SOLICITATION AMENDMENT MODIFICATION DE L'INVITATION

Title - Sujet PIRATES Turret Update		
Solicitation No. - N° de l'invitation W7701-186676/A		Amendment No. - N° modif. 004
Client Reference No. - N° de référence du client W7701-186676		Date 2018-01-30
GETS Reference No. - N° de référence de SEAG PW-\$BAL-001-17299		
File No. - N° de dossier BAP-7-40215 (001)	CCC No./N° CCC - FMS No./N° VME	
Solicitation Closes - L'invitation prend fin at - à 02:00 PM on - le 2018-02-15		Time Zone Fuseau horaire Heure Normale du l'Est HNE
F.O.B. - F.A.B.		
Plant-Usine: <input type="checkbox"/> Destination: <input checked="" type="checkbox"/> Other-Autre: <input type="checkbox"/>		
Address Enquiries to: - Adresser toutes questions à: Tremblay, Marial		Buyer Id - Id de l'acheteur bal001
Telephone No. - N° de téléphone (418) 677-4000 (4159)		FAX No. - N° de FAX () -
Destination - of Goods, Services, and Construction: Destination - des biens, services et construction: Defence R & D Canada - Valcartier / R et D Défense Canada - Valcartier 2459 route de la Bravoure Québec (Québec) G3J 1X5

Questions/Answers during optional site visit on January 25th, 2018

All other terms and conditions of the solicitation remain the same.

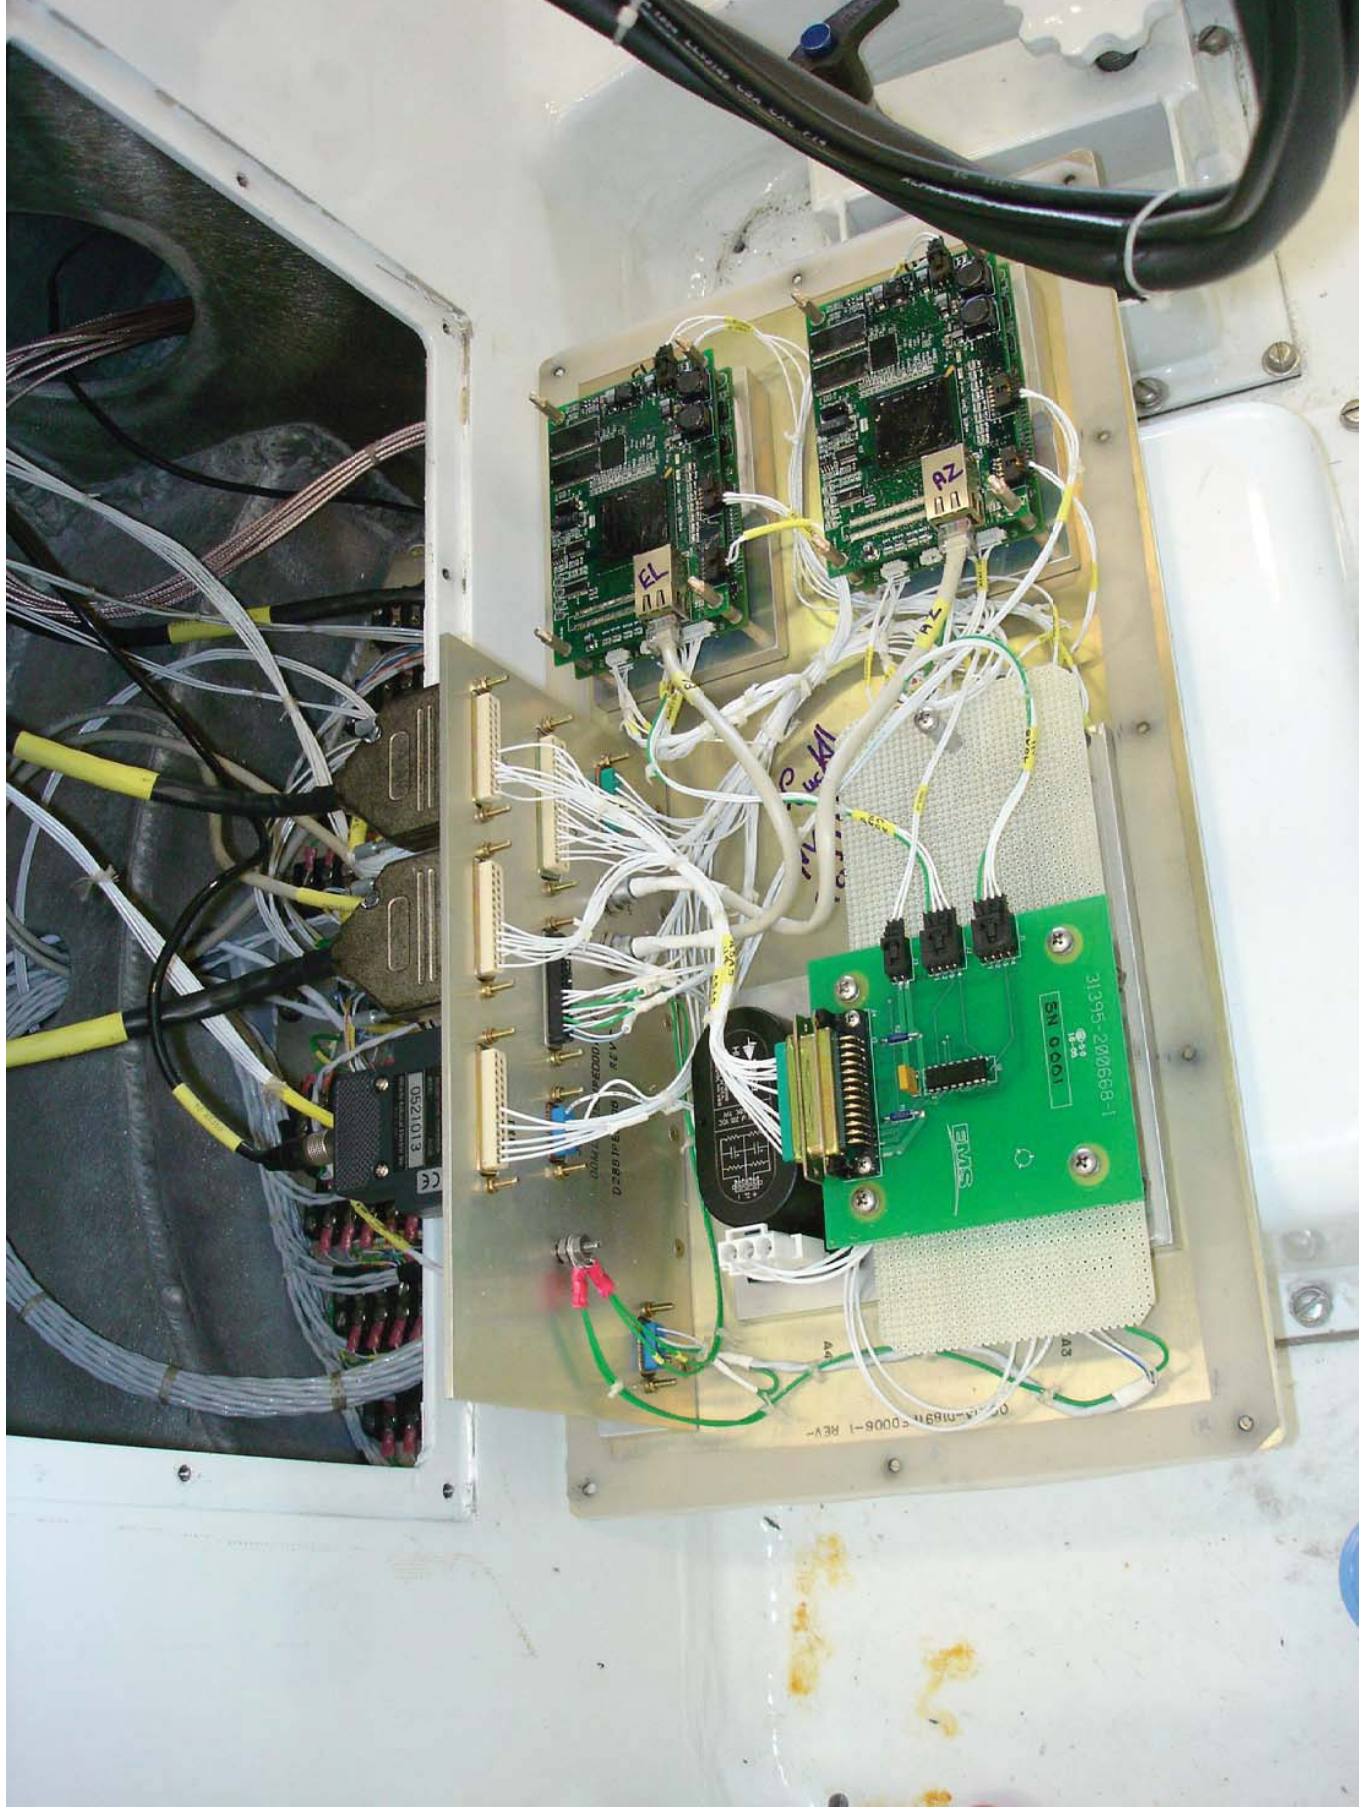
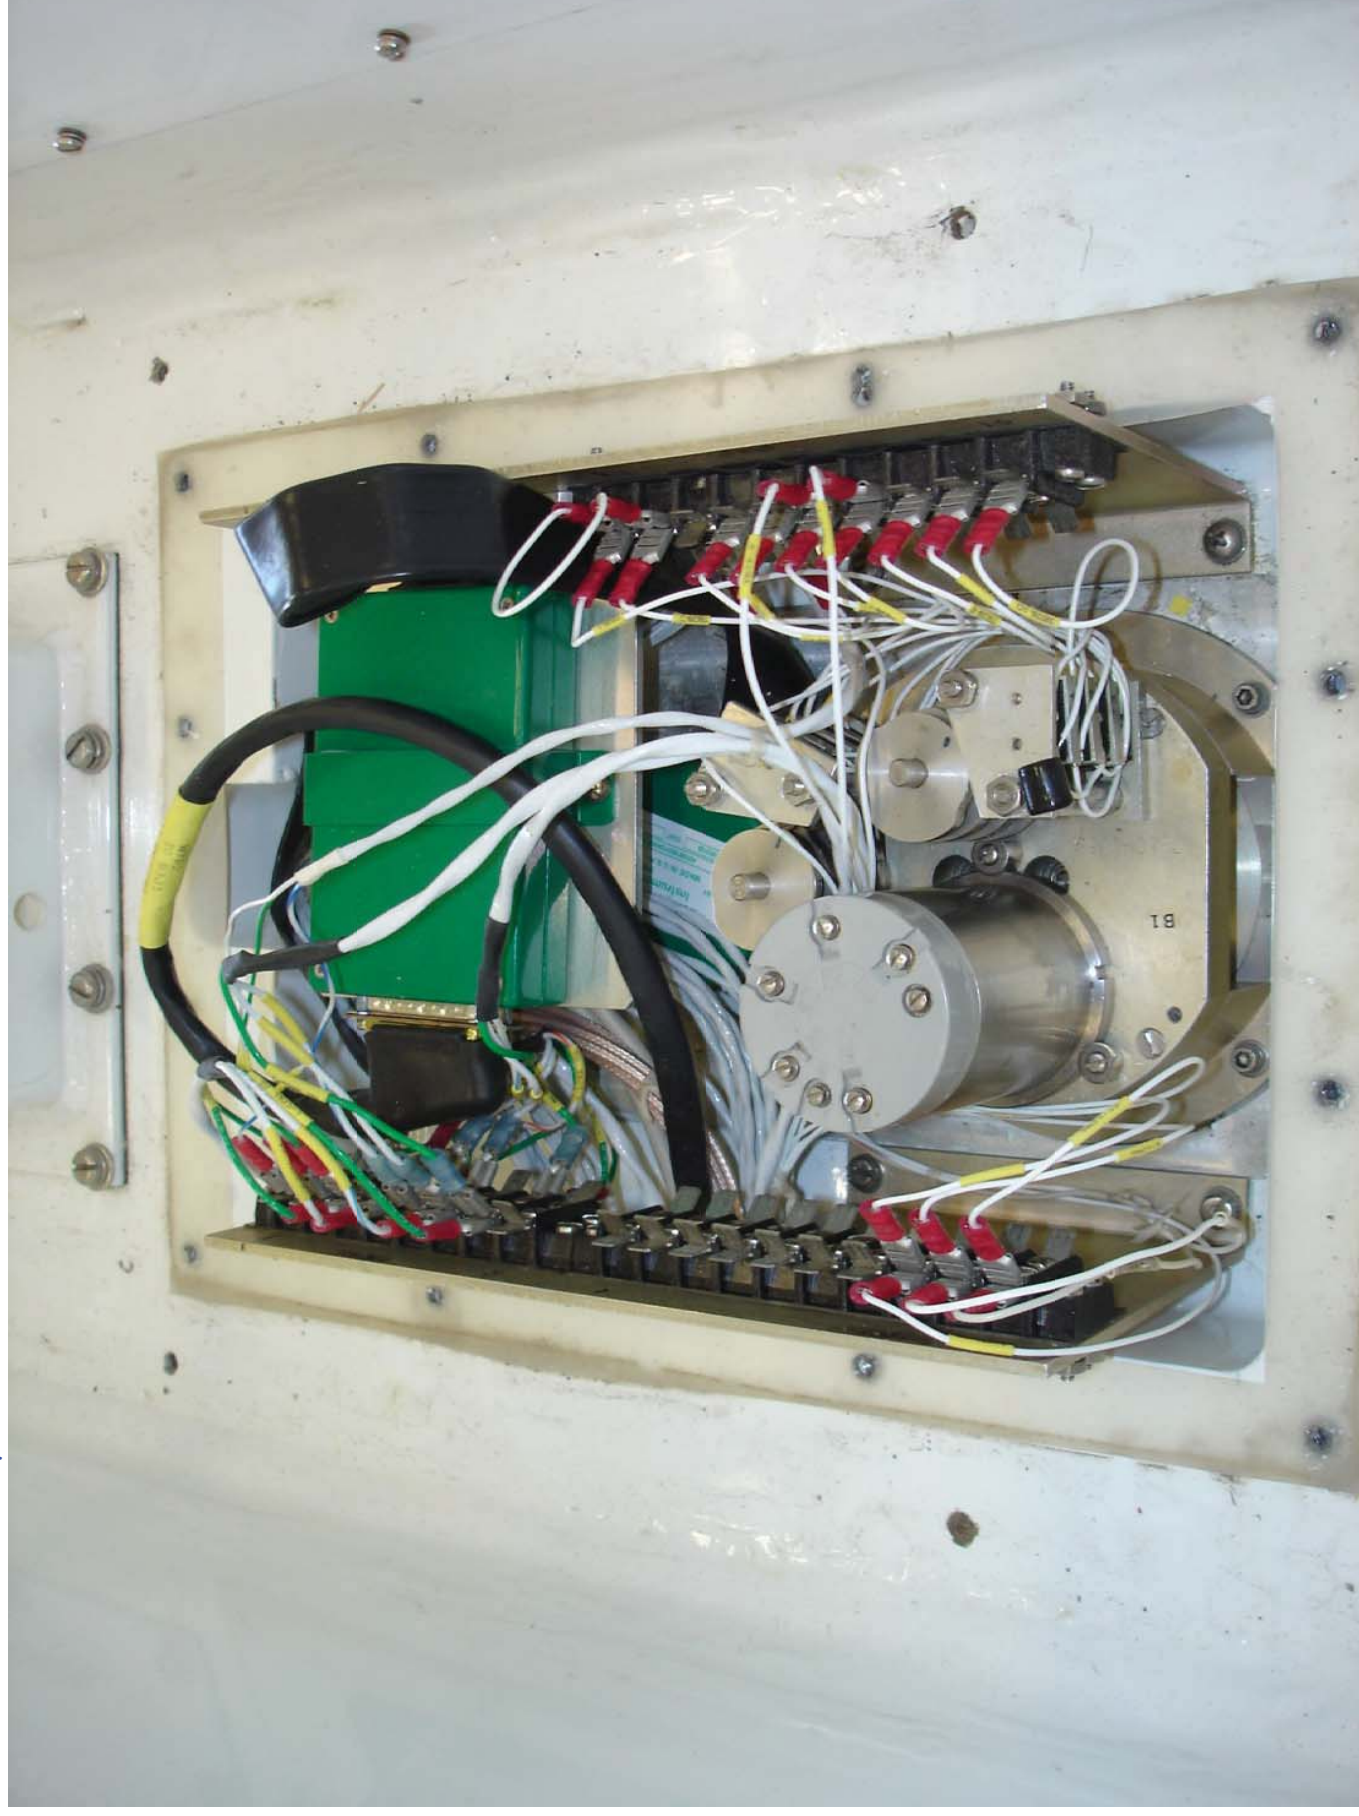
Can you supply us with the pictures + figure 2-2 of the manual?

Answer 23: Pictures and Figure 2.2 of the manual are attached to this amendment.
